# INNER WEST COUNCIL

## DEVELOPMENT ASSESSMENT REPORT

<b>Application No.</b>	D/2018/445
<b>Address</b>	59A Reynolds Street, Balmain NSW 2041
<b>Proposal</b>	Additions and alterations to existing dwelling house and construction of a three storey residential flat building containing seven units over basement parking, and associated works, including retaining wall and fence works.
<b>Date of Lodgement</b>	24 August 2018
<b>Applicant</b>	Bonheur Holdings Pty Ltd
<b>Owner</b>	Mrs. O. Stasinopoulos
<b>Number of Submissions</b>	29
<b>Value of works</b>	\$6,694,026
<b>Reason for determination at Planning Panel</b>	<ul style="list-style-type: none"> <li>• Number of individual submissions exceeds 10</li> <li>• Non-compliances with Landscaped Area development standard exceeds 10%</li> <li>• SEPP 65</li> </ul>
<b>Main Issues</b>	<ul style="list-style-type: none"> <li>• Floor space ratio exceedance</li> <li>• Insufficient Landscaped Area</li> <li>• No clause 4.6 request</li> <li>• SEPP 65 and ADG</li> <li>• Non-compliances with LLEP 2013 and LDCP 2013</li> <li>• Heritage</li> <li>• Stormwater</li> </ul>

<b>Recommendation</b>	Refusal
<b>Attachment A</b>	Architectural Plans and Landscape Plans

Figure 5: West elevation (Source: Submitted Plans)

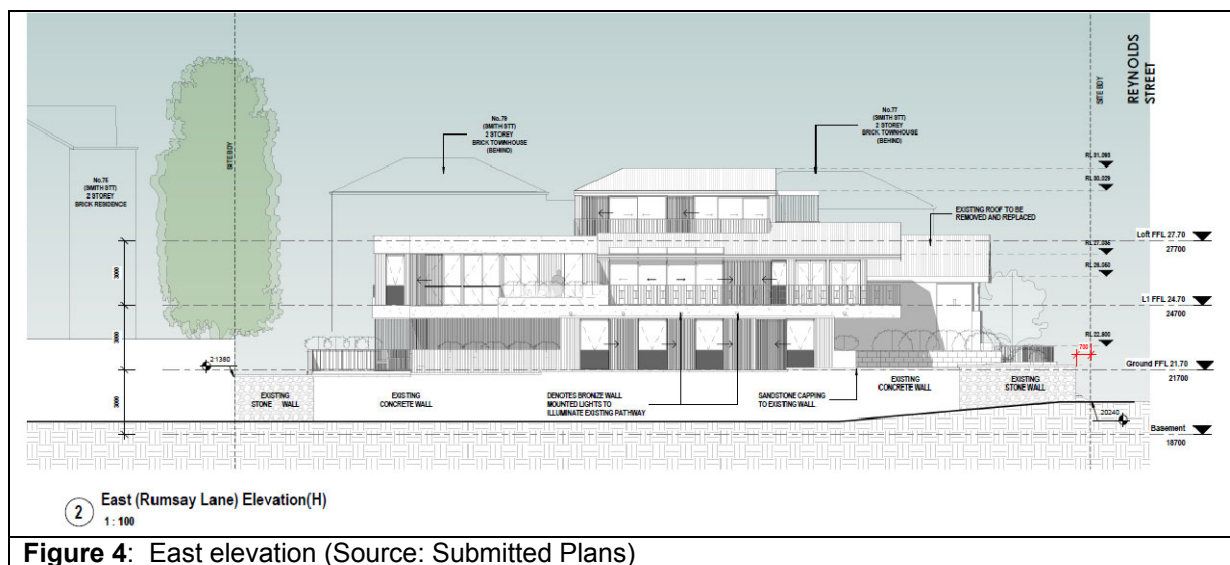
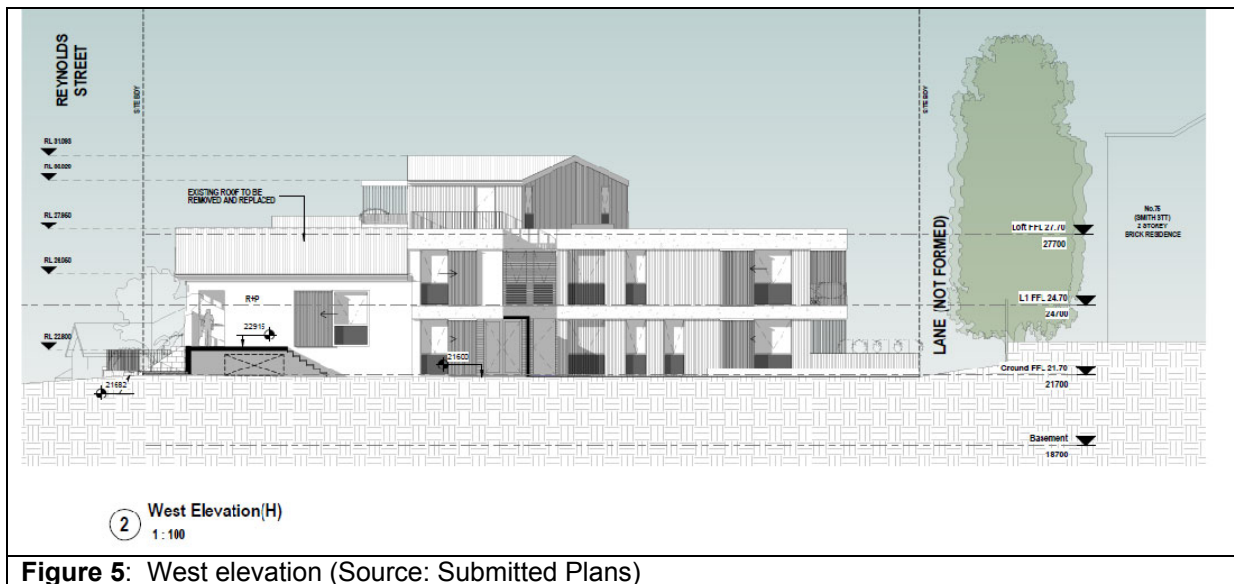
Given the dense nature of surrounding development and the width of the site (approximately 16m), it is not feasible to achieve the ADG required setbacks. Instead, the submitted Statement of Environmental Effects states that the development will rely upon obscure glass, shutters, operable and fixed screens to provide suitable privacy protection but these are not notated on the submitted plans. The proximity of surrounding residential development raises concern as to the impacts on the visual impacts upon neighbours.

However, as the proposal is new development in an established area it should be located and oriented to maximise visual privacy between buildings on site and for neighbouring buildings. The proposal includes large expanses of glazed area and balconies on both the eastern and western elevations (refer to **Figures 4 & 5**), primarily to provide adequate solar access to each new unit (internal and external areas) but this gives rise to the concern for the protection of privacy between the proposal and neighbouring properties. As the proposal relies solely on private open space areas (balconies) for outdoor amenity within the development, the active nature of these balconies is likely to increase the incidence of overlooking neighbouring properties.

It is considered that it will be difficult to add privacy protection measures to these balconies without adding unnecessarily to the overall bulk of the development &/or interfering with the amenity of the internal areas of the new units and their associated private open space areas.

1 Basement  
1:100

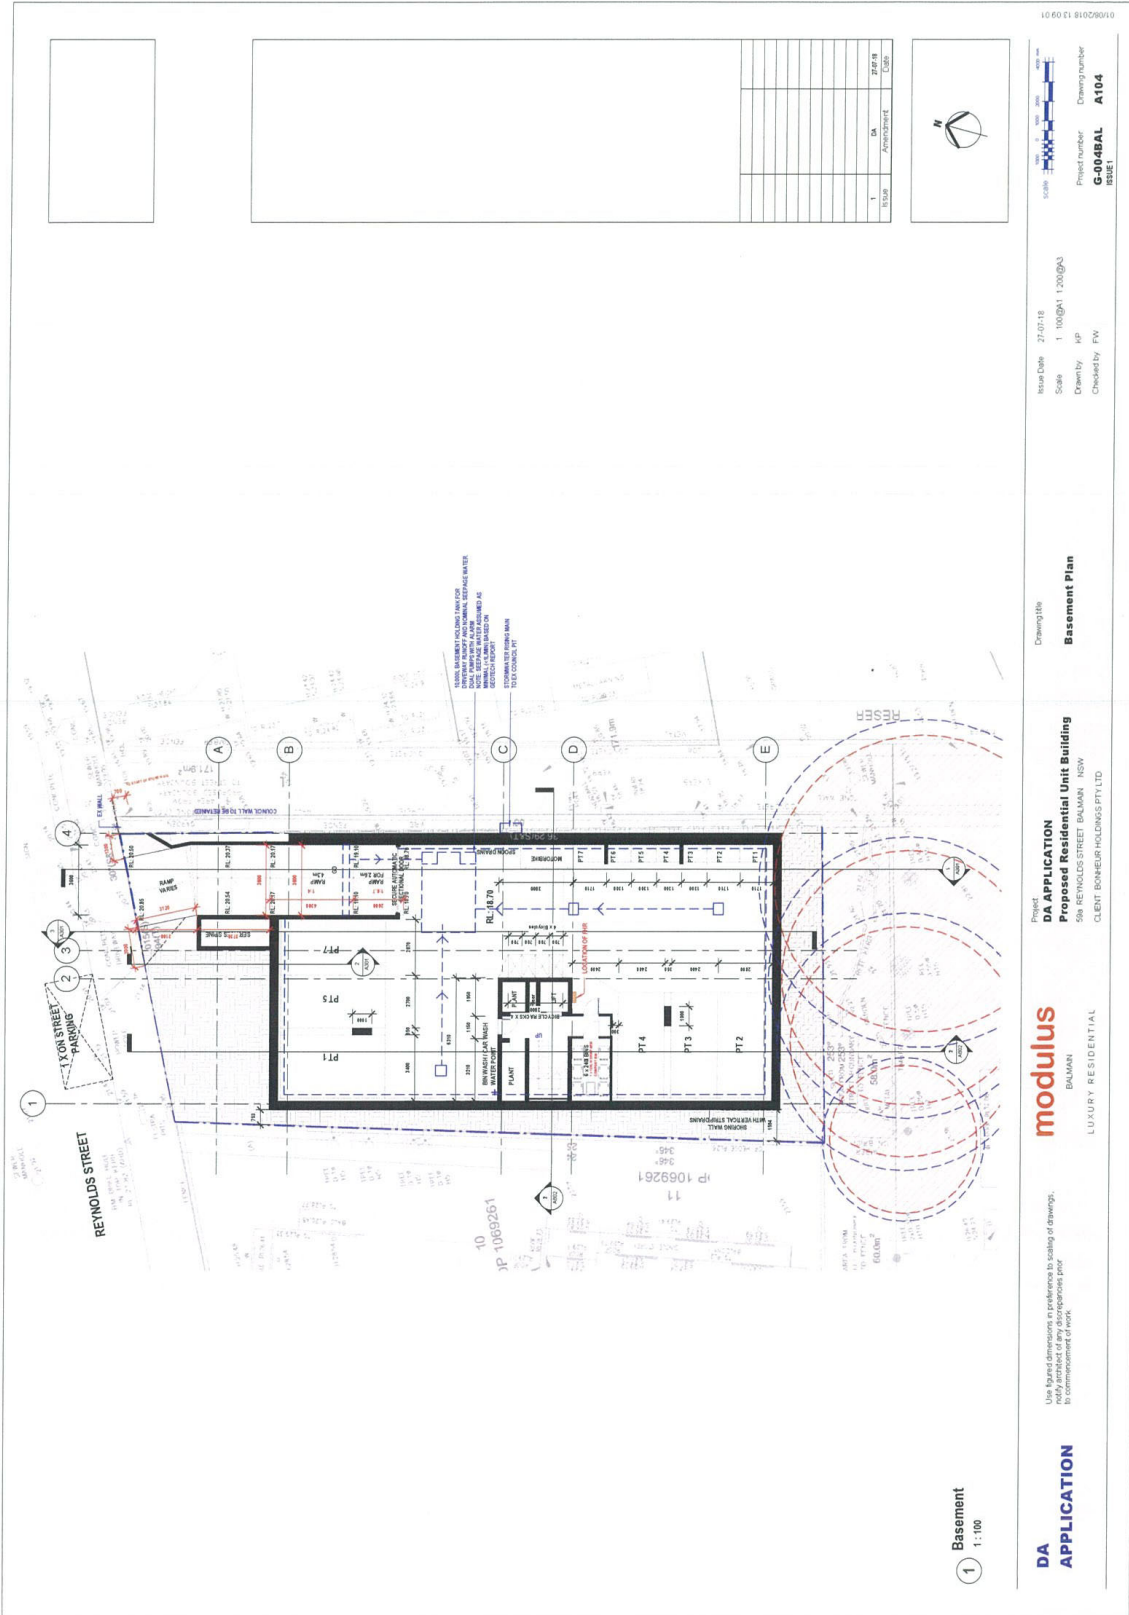
- a) *Access and manoeuvrability to Space 3 and Space 4 is restricted due to the location of the lifts and bicycle parking. The lifts and bicycle parking should be relocated to provide improved access to Space 3 and Space 4 and provide parking facility dimensions that comply with Figure 2.2 of AS/NZS 2890.1-2004 for User class 1A (as a minimum).*
- b) *The parking aisle must comply with the Blind Aisle requirements of the Standard, as defined by Clause 2.4.2(c) of AS/NZS 2890.1-2004.*
- c) *A dedicated car wash bay must be provided on site in a location that does not prevent access to the parking facilities. Details of the car wash bay including bunding and connection to sewer must be detailed on the plans.*
